**DRAFT DECISION**

**CitiPower**

**Distribution determination**

**Capital expenditure**

**Figure A.1 CitiPower's historical and target SAIFI performance 2006 to 2026**

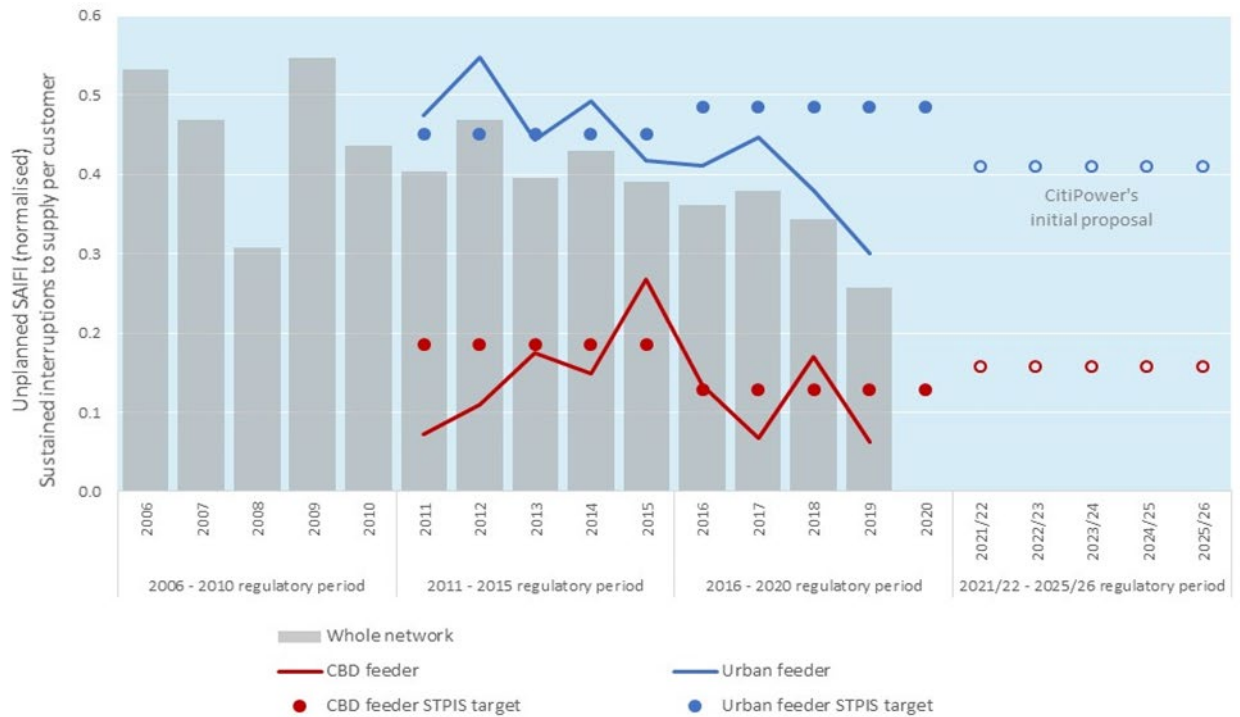
- We are not convinced that CitiPower's forecast material step-up relative to the current period is required given CitiPower has successfully managed and maintained its network over the current regulatory control period. Figure A.1 below shows that CitiPower outperformed its SAIFI targets in the first four years of the current regulatory control period (2016 to 2019), while underspending its capex forecast. These result provides us confidence that CitiPower's revealed recurrent expenditure is likely to be reflective of its future repex requirements, unless CitiPower demonstrates otherwise.

**Figure A.2 Long-term trend of repex from 2009 to 2026**  
 (\$ million, 2020–21)

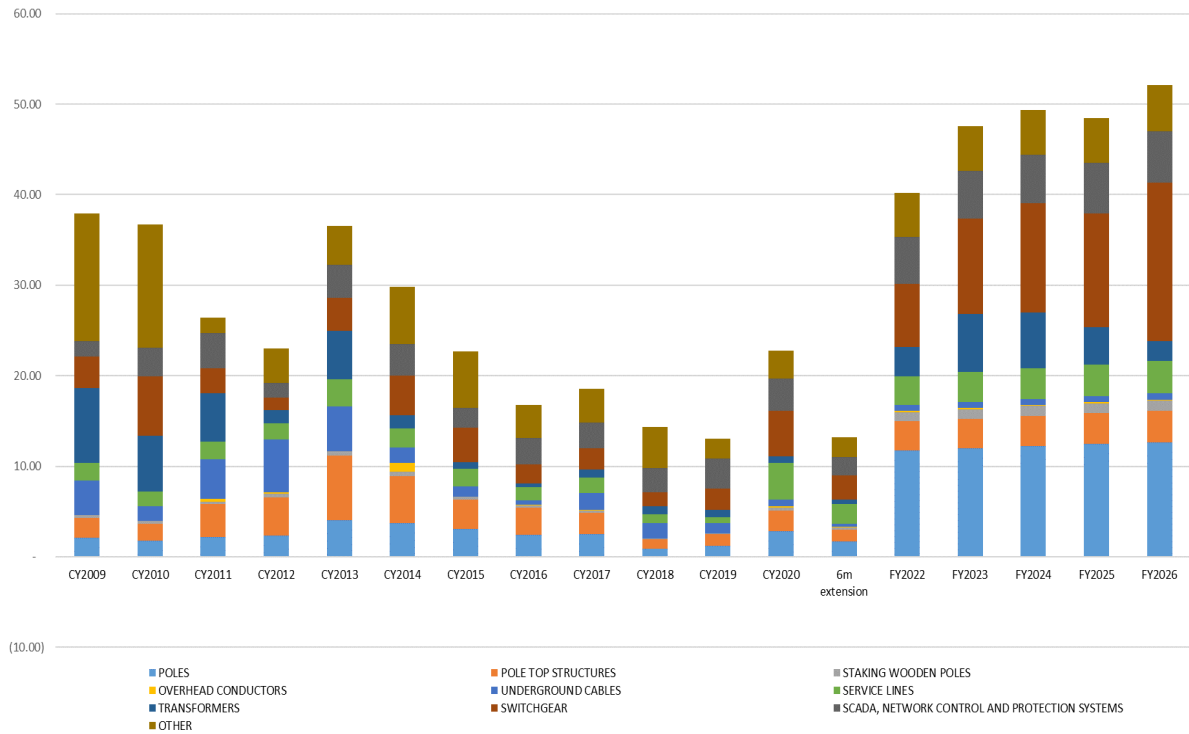
CitiPower's forecast \$260 million is approximately 200 per cent above its average historical repex over the 2016–19 regulatory control years, as shown in Figure A.2.

**Figure A.3 Repex modelling results (\$ million, 2020–21)**

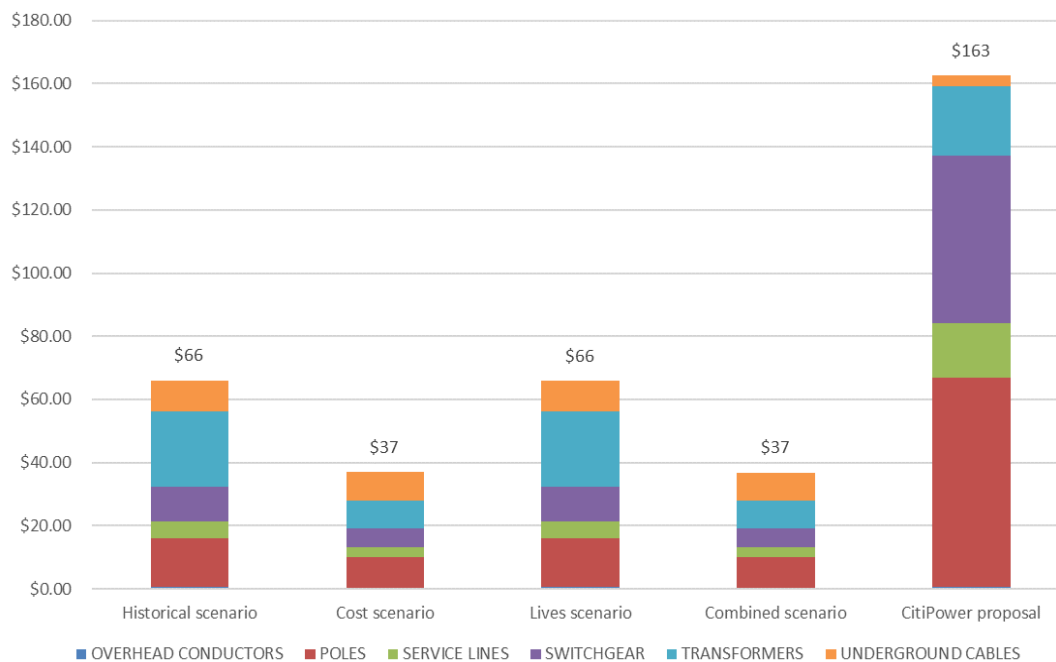
Figure A.3 below shows CitiPower's proposed modelled repex compared with the four scenarios. CitiPower's proposed \$163 million is \$97 million higher than the repex model threshold, which is the lives scenario.<sup>34</sup>

The results show that CitiPower's forecast for poles, service lines and switchgear are materially higher than what the model predicts. In reviewing these results, we have had regard to previous consultation processes as well as GHD's report, which was provided as part of CitiPower's regulatory proposal.<sup>35</sup> GHD noted that smaller networks, such as CitiPower, may have lumpy expenditure which may not be suitable

**Figure A.4 CitiPower's historical and forecast wood poles repex and interventions (\$ million, 2020–21)**

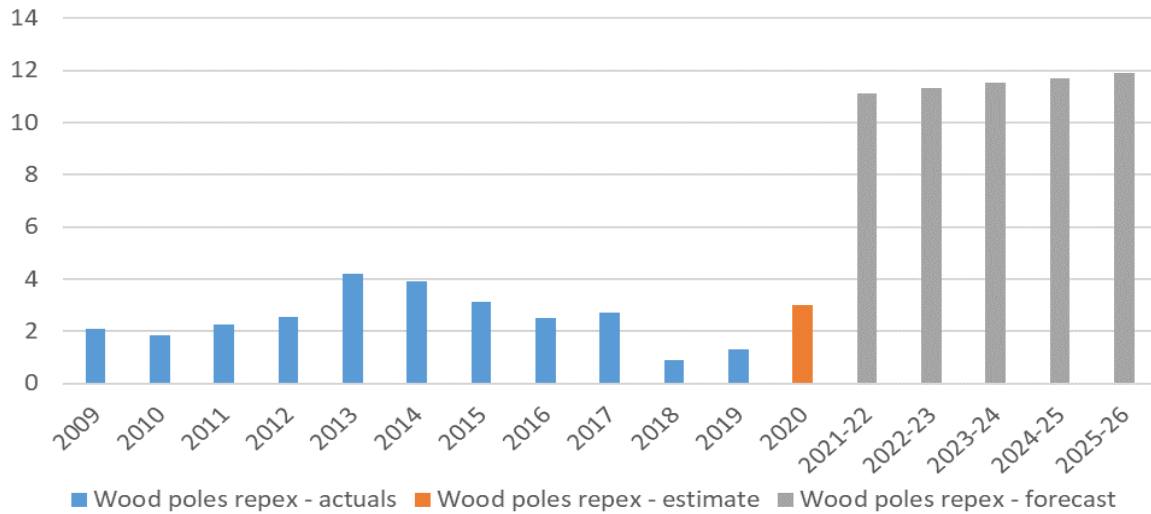
Figure A.4 shows the magnitude of the increase in forecast wood poles repex relative to historical trends. Historically, wood poles repex peaked in 2013 and decreased to \$0.9 million in 2018. The increase in 2019 actual and 2020 estimated repex reflects changes to CitiPower's asset management practices.

**Figure A.5 Trend of forecast transformer repex from 2009 to 2026 (\$ million, 2020–21)**

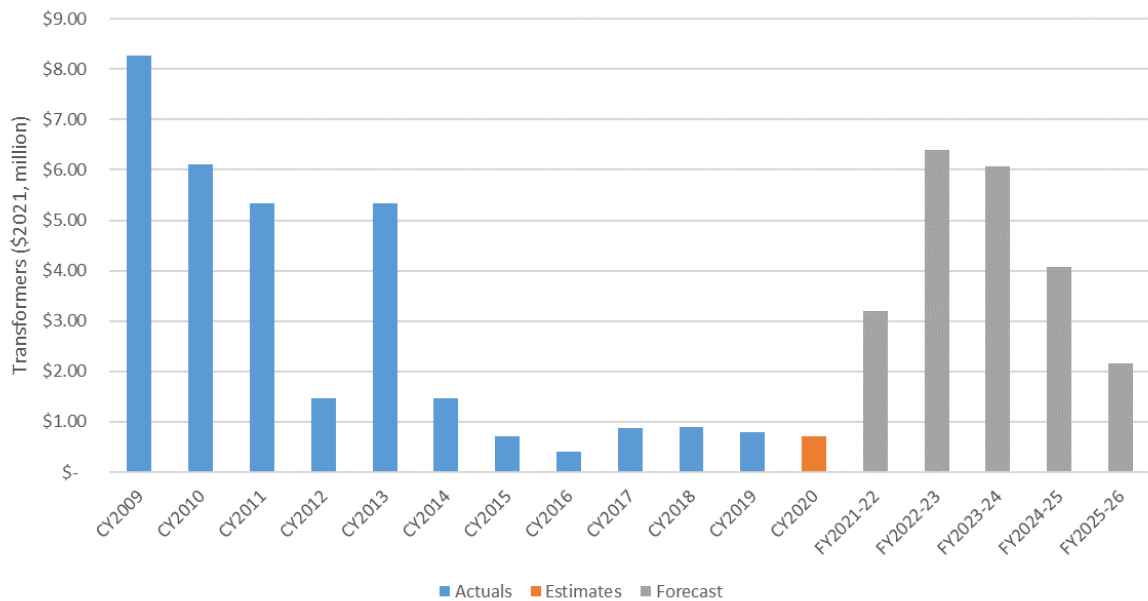
CitiPower included \$21.9 million (\$2020–21, includes real cost escalation) for transformers repex over the forecast regulatory control period. The forecast is 487.9 per cent higher than its actual transformer repex over the current regulatory control period. Figure A.5 below shows the long term trend of CitiPower's transformers repex, which demonstrates an expenditure profile of a non-recurrent nature.

CitiPower's forecast transformers repex is largely made up of a program of works to replace five of its zone substation transformer replacements,<sup>59</sup> which makes up approximately \$20.3 million of the proposed amount.<sup>60</sup> The remainder of CitiPower's transformers repex relates to indoor and kiosk substation transformer replacements.<sup>61</sup>

Our substitute estimate applies lower unit rates for zone substation replacements, but allows the replacement of all five zone substation transformers. It relies on GHD's unit cost for CitiPower.<sup>68</sup> This unit cost was also proposed by CitiPower, itself, to use for zone substation transformers in the repex model.<sup>69</sup> Given our and EMCA's concerns around the need to replace all the proposed transformers within the 2021–26 regulatory control period, we also tested our substitute estimate using a substitute methodology, namely to rely on a higher unit rate for zone substation transformers (approximately \$2 million)<sup>70</sup>, while reducing the proposed transformer replacement volume to four zone substation transformers (to exclude VM1). Our substitute methodology supports our substitute estimate (it is within \$200,000). We are therefore satisfied that our substitute estimate is sufficient and gives CitiPower the flexibility to maintain the quality, safety and reliability of its transformers asset population. It is also consistent with the approach to not prescribe projects and programs that a distributor undertakes.

**Figure A.6 Long term trend of switchgear repex from 2009 to 2026**  
 (\$ million, 2020–21)

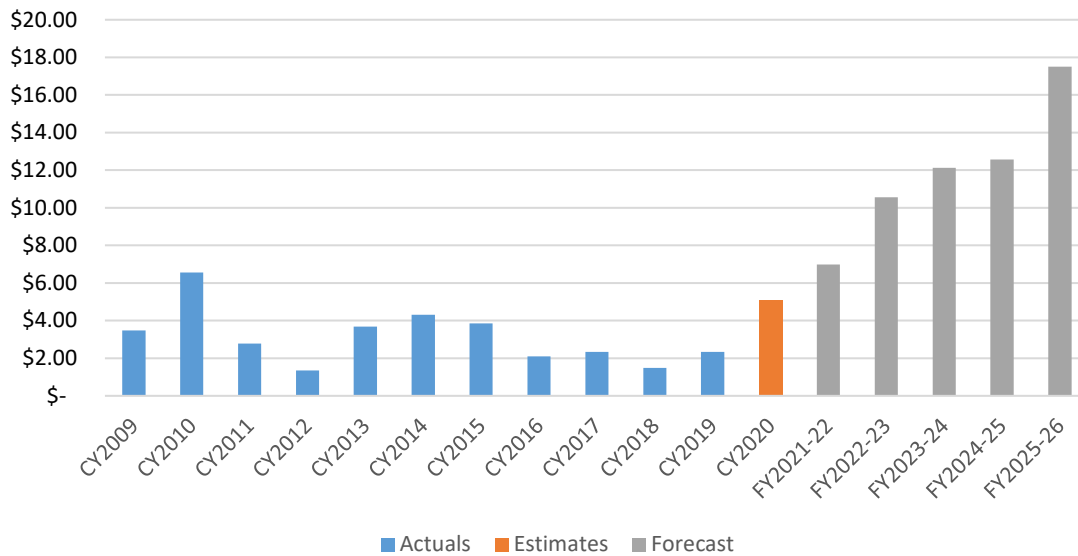
CitiPower forecasts \$59.7 million (\$2020–21, includes real cost escalation) for switchgear repex over the 2021–26 regulatory control period. The forecast is a 530 per cent step up from 2016–19 actual repex. Figure A-6 below shows the long term trend of switchgear repex over time.

**Figure A.9 CitiPower's pole top structure forecasting methodology**

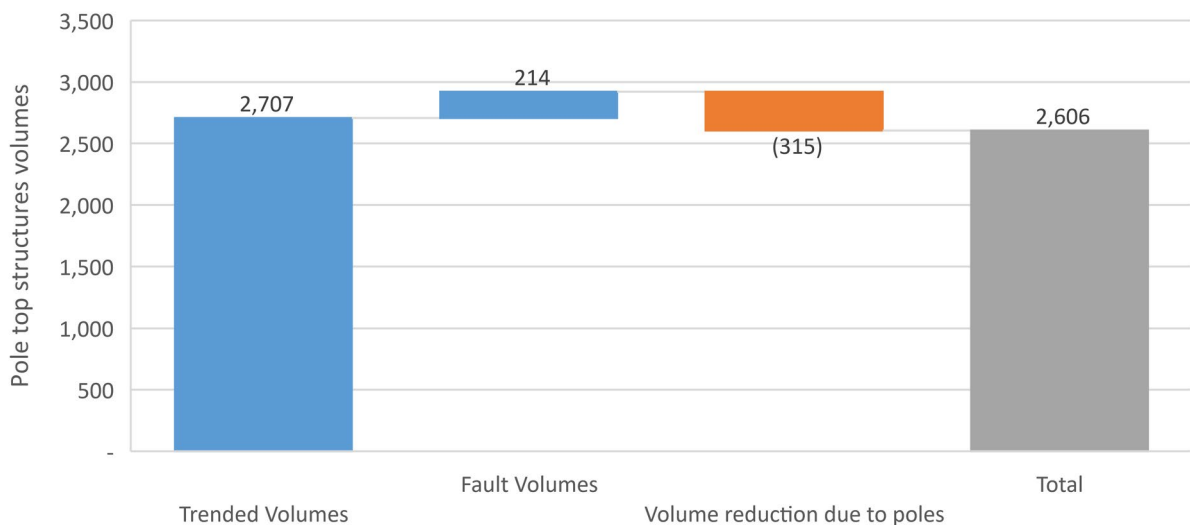
CitiPower has relied on trended volumes and historical unit rates over the 2014–18 years to build its forecast requirements over the 2021–26 regulatory control period. CitiPower also added volumes for fault related capital, and a negative adjustment to take into account its increased replacement of poles.<sup>107</sup> Figure A.9 shows CitiPower's forecasting methodology for pole top structure volumes.

- CitiPower's proposed reduction to account for the increase in its proposed pole replacement program is likely to be insufficient. EMCa noted that the derivation of the negative adjustment was not provided. However, EMCa estimated that the proposed incremental increase in poles could result in negative adjustment of 159 units per annum (a total of 795 pole top structures)<sup>110</sup> rather than CitiPower's proposed negative adjustment of 315 pole top structures, which is shown in Figure A.9 above.

**Figure A.10 Annuitised costs and modelled benefits of one transformer upgrade (\$2020–21)**

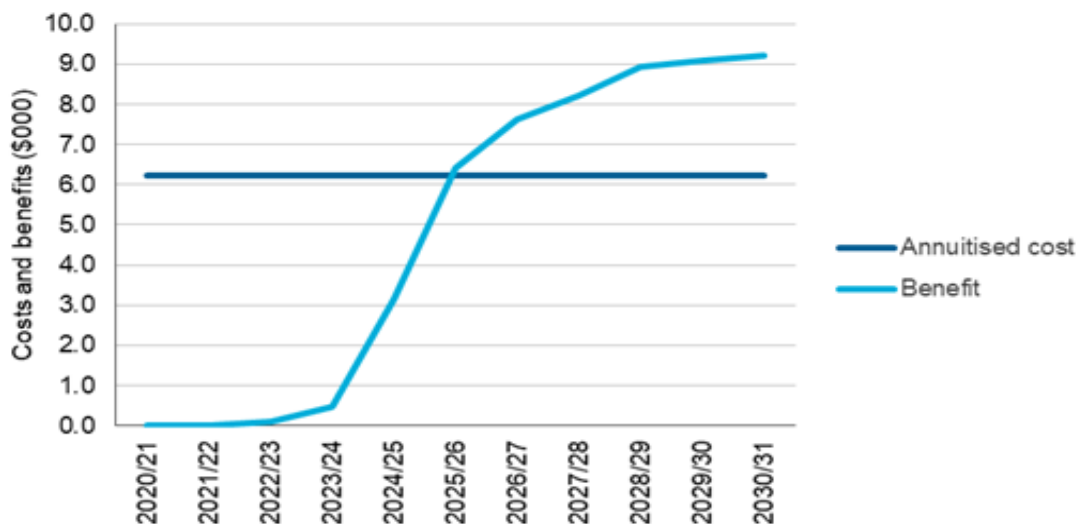
The applied approach brings forward augmentations when they are still uneconomic, but have a positive NPV only because their forecast of distant future positive net benefits is offsetting the still negative net benefits within the forecast period. The standard approach is to identify when the annual benefits exceed the annual costs, in this case represented by the annuitised cost of the upgrade being considered. EMCA's analysis highlighted that the net benefits to customers are far smaller if these augmentations are undertaken before this time. Figure A.10 below outlines an example of this analysis and highlights that the optimal investment timing for this specific transformer is 2025–26.<sup>132</sup>

Figure A.10 highlights that the annual benefits of this distribution transformer upgrade are not expected to exceed the annualised costs until 2025–26. This type of analysis is consistent with how some distributors propose and we typically assess repex and traditional augex proposals. Figure A.11 below outlines the analysis CitiPower undertook for its CBD security augex project. It used this approach to ascertain the optimal timing of each of its traditional augex proposals but has not done so for DER.

**Figure A.12 CitiPower's historical vs forecast traditional augex (\$ million, 2020–21)**

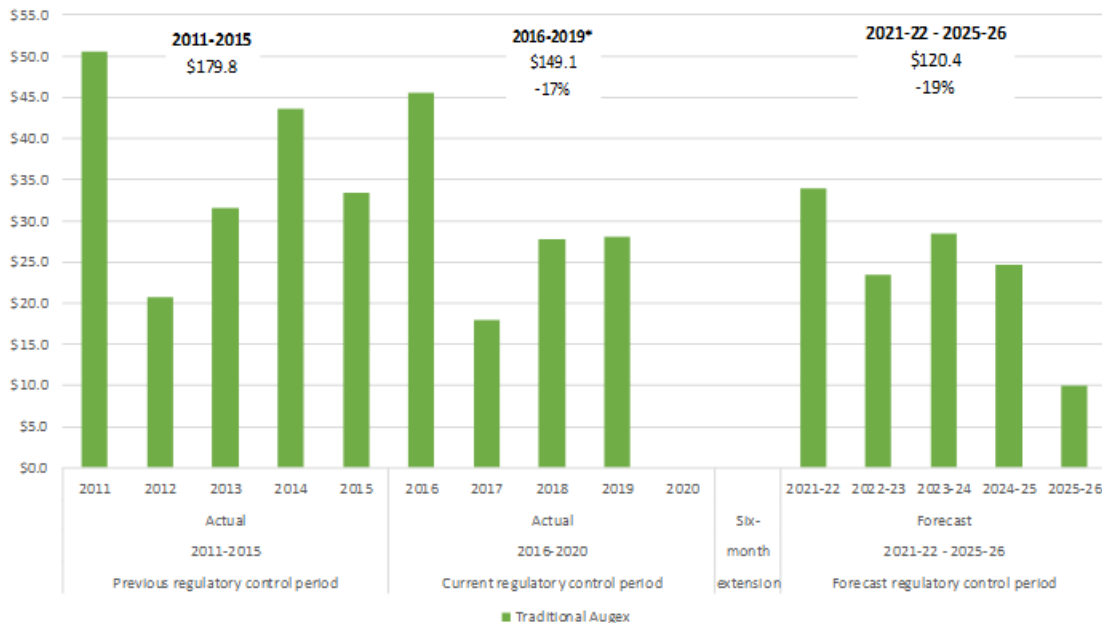
As discussed in Section B (Forecast Demand), CitiPower's maximum demand forecasts are materially overstated. However, CitiPower has forecast a 19 per cent decrease in yearly traditional augex, compared to actuals over the 2016–2019 regulatory control years, as shown in Figure A.12.

**Figure A.14 Victorian ICT benchmarking – Recurrent ICT totex per customer (\$ million, 2020–21)**

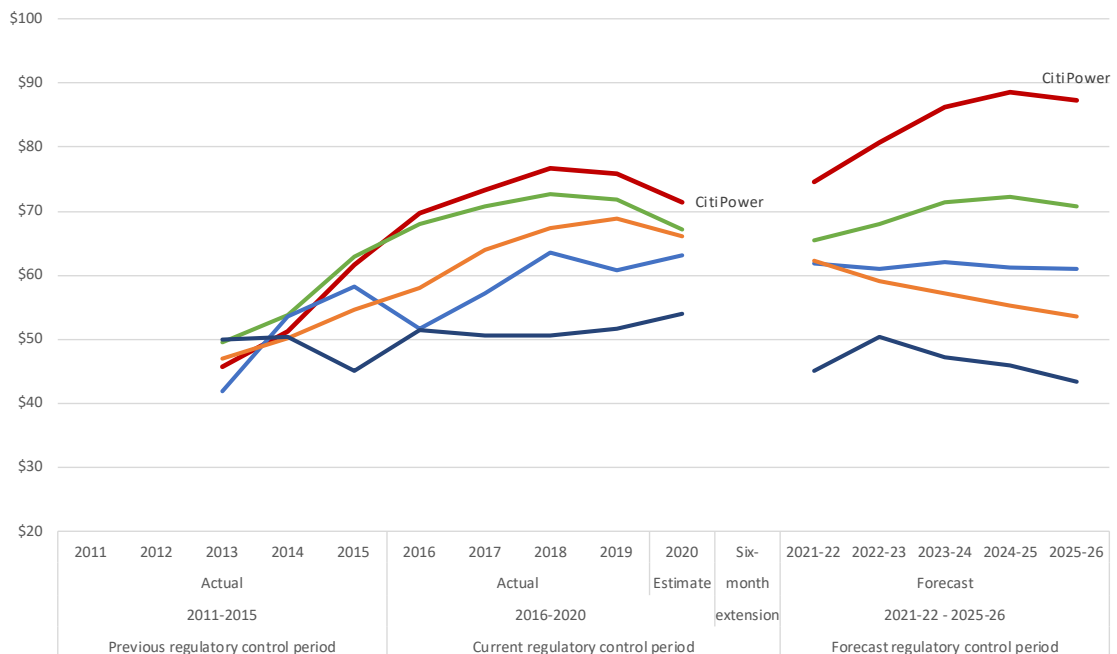
Figure A.14 highlights CitiPower's actual recurrent ICT totex per customer ranged from \$45 to \$72 between 2013 and 2019, and is expected to fall just below \$90 per customer over the forecast regulatory control period. This places CitiPower at the upper end of the five Victorian distributors for recurrent ICT totex per customer both in terms of historical revealed expenditure and forecast expenditure.

**Figure A.15 Victorian ICT benchmarking – Recurrent ICT totex per end user (\$ million, 2020–21)**

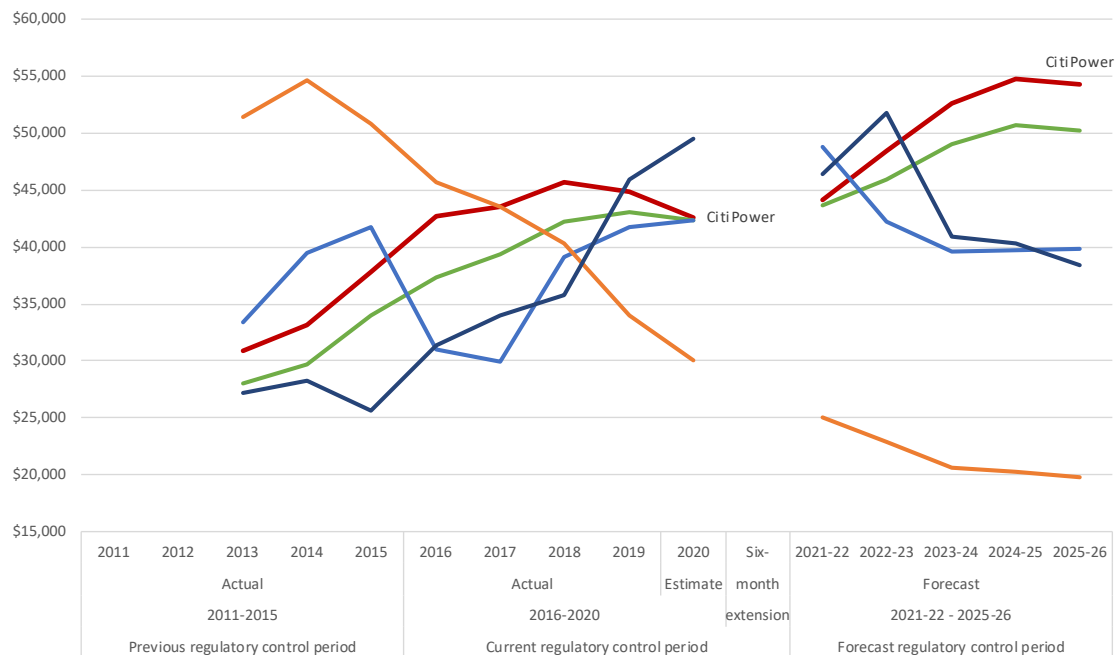
Figure A.15 illustrates CitiPower's actual recurrent ICT totex per end user has increased sharply from 2013 to 2019. Since 2017, the five Victorian distributors have spent between approximately \$30,000 and \$45,000 in ICT totex per end user. CitiPower's forecast places it at the upper end of this benchmarking metric compared with the other distributors, particularly by the end of the forecast period.

**Figure B.2 CitiPower's historical and forecast maximum non-coincident demand (MW, PoE50) <sup>193</sup>**

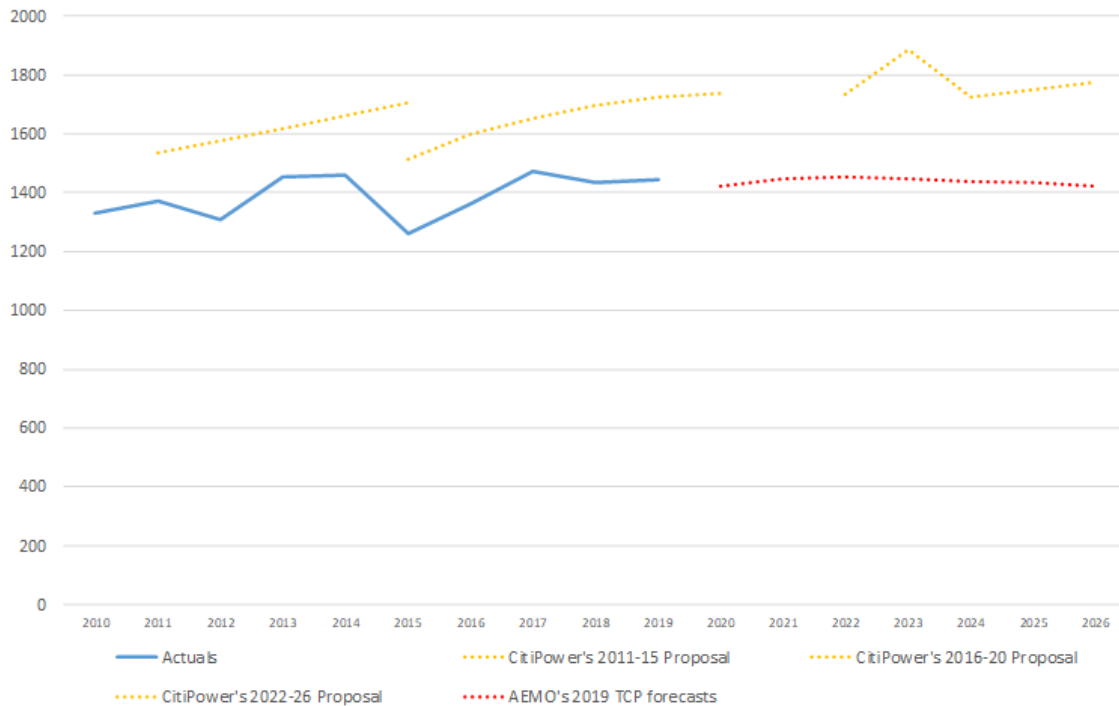
As shown in Figure B.2, CitiPower forecast strongly rising maximum demand in its 2011–16 proposal and its 2016–20 proposal. In both cases this increase did not eventuate.

To forecast its opex, CitiPower has included maximum demand forecasts in its RIN that are higher still (shown in Figure B.2 above). CitiPower’s proposal does not discuss this large discrepancy. We consider CitiPower should have transparently identified and argued for the large difference between these forecasts initially to justify any increase in its demand forecast above those produced by regression modelling. The remainder
